TITLE: GTA04b7

Date: 03.10.14 23:14

## LEDs

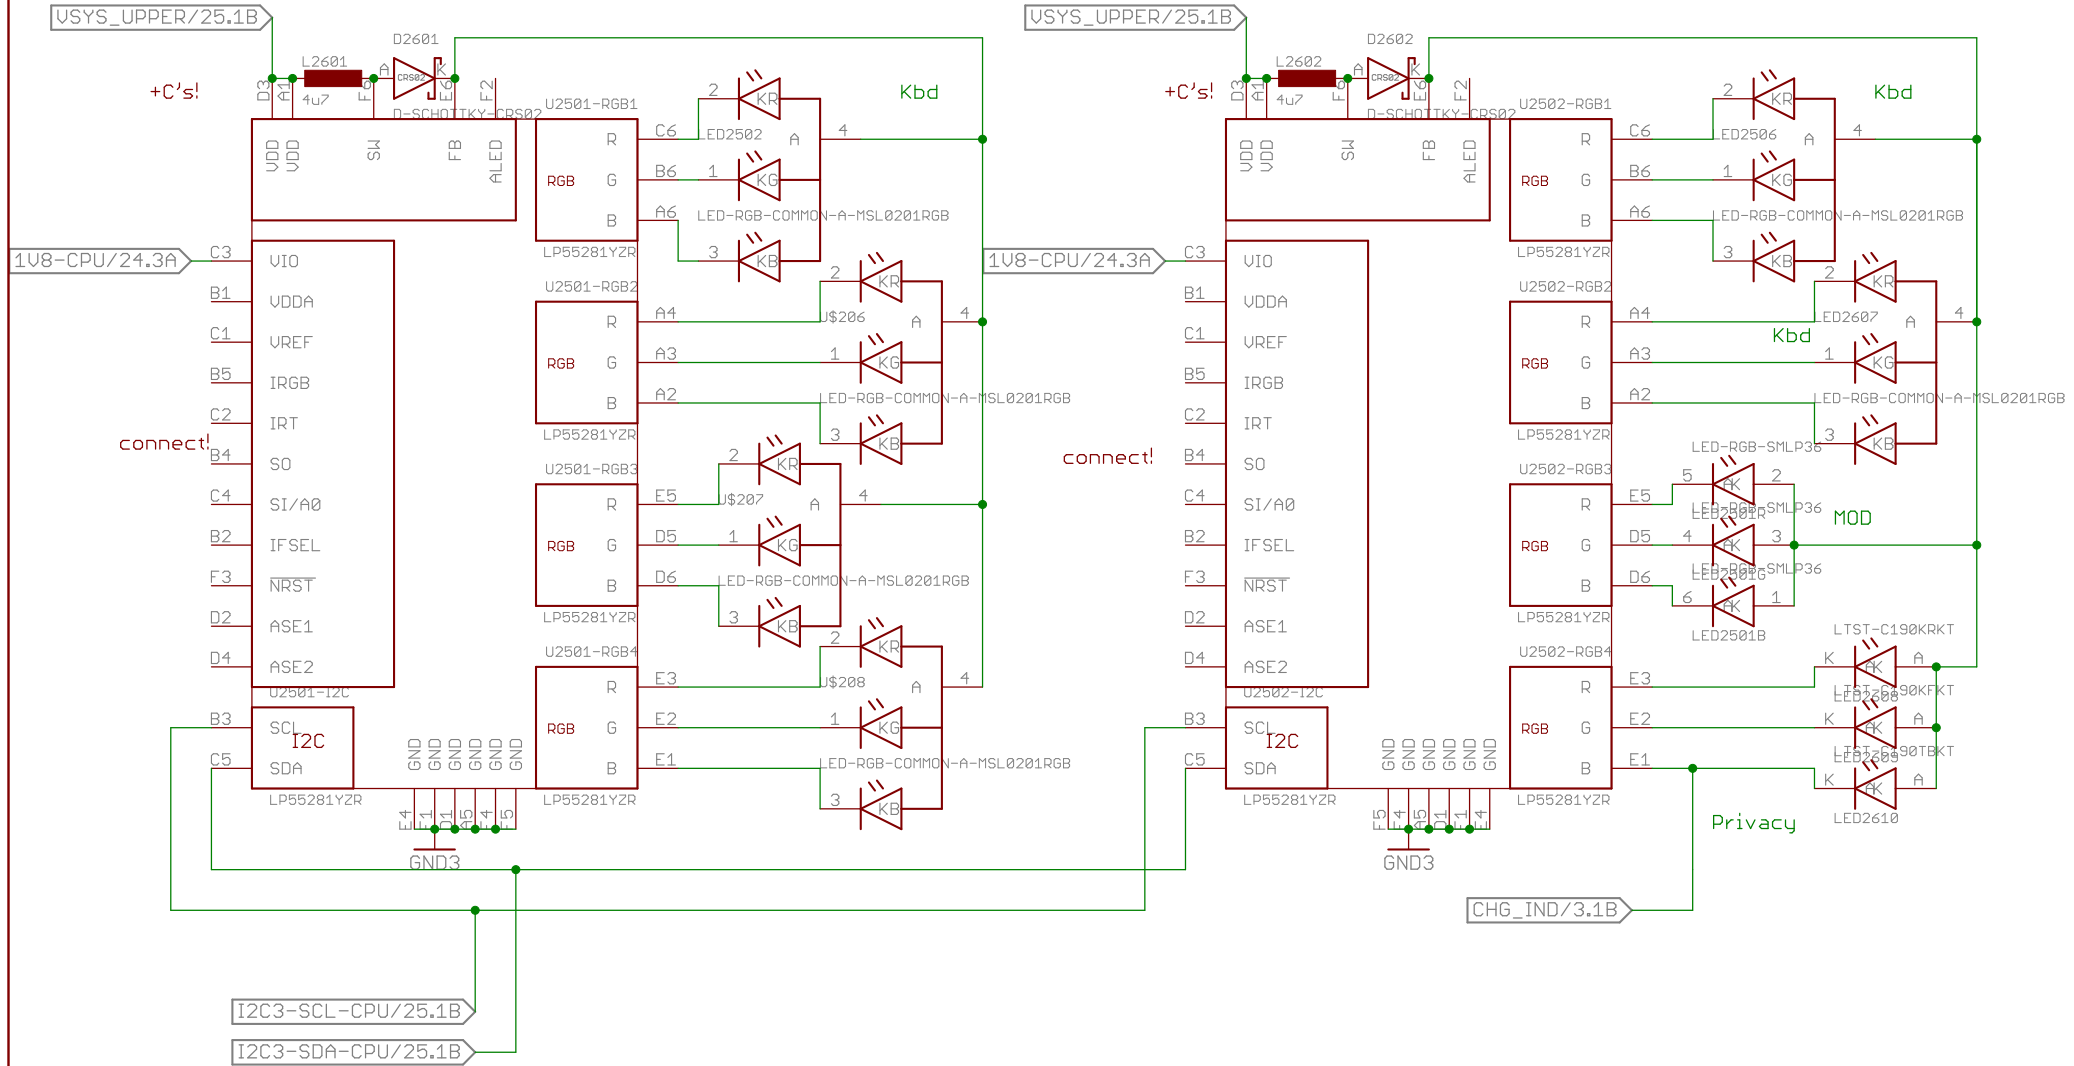
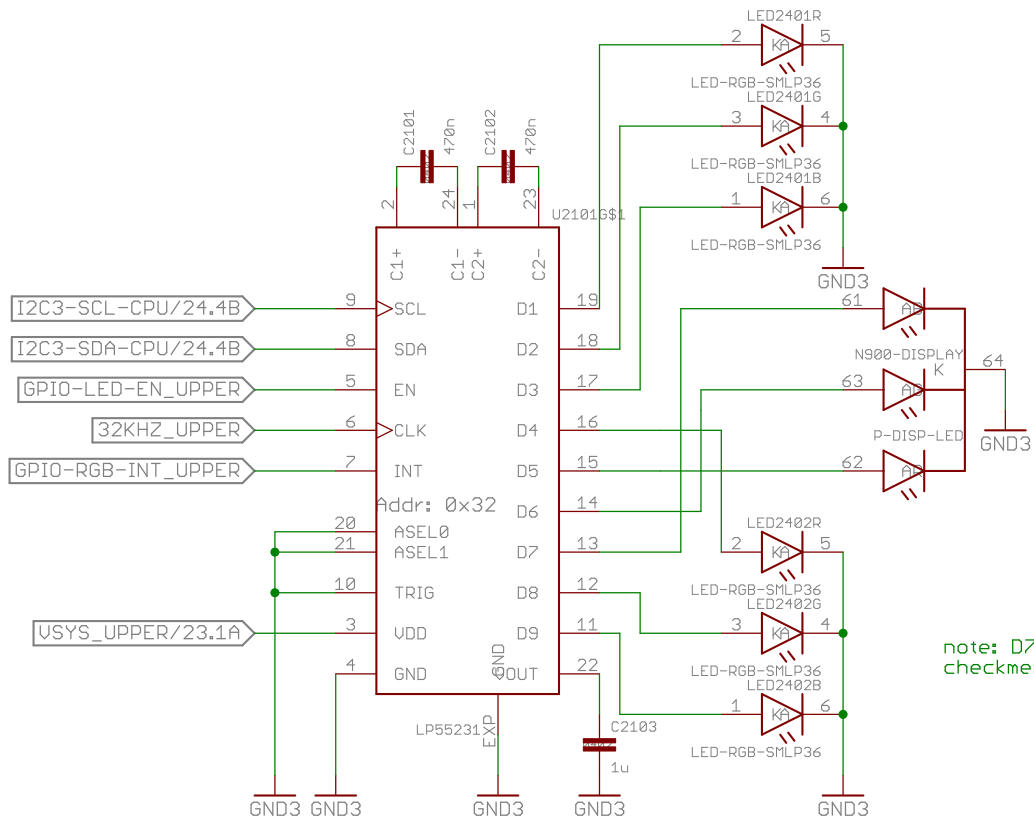
note: D7, D8, D9 are powered differently!  
checkme: assignment of LED location to output number

## Connector to BB

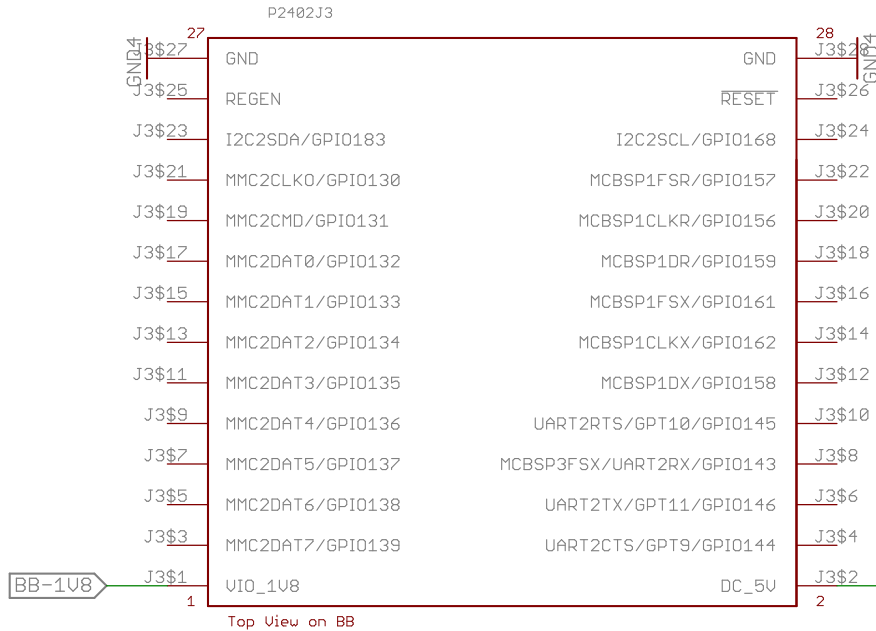
1v8???

reverse?
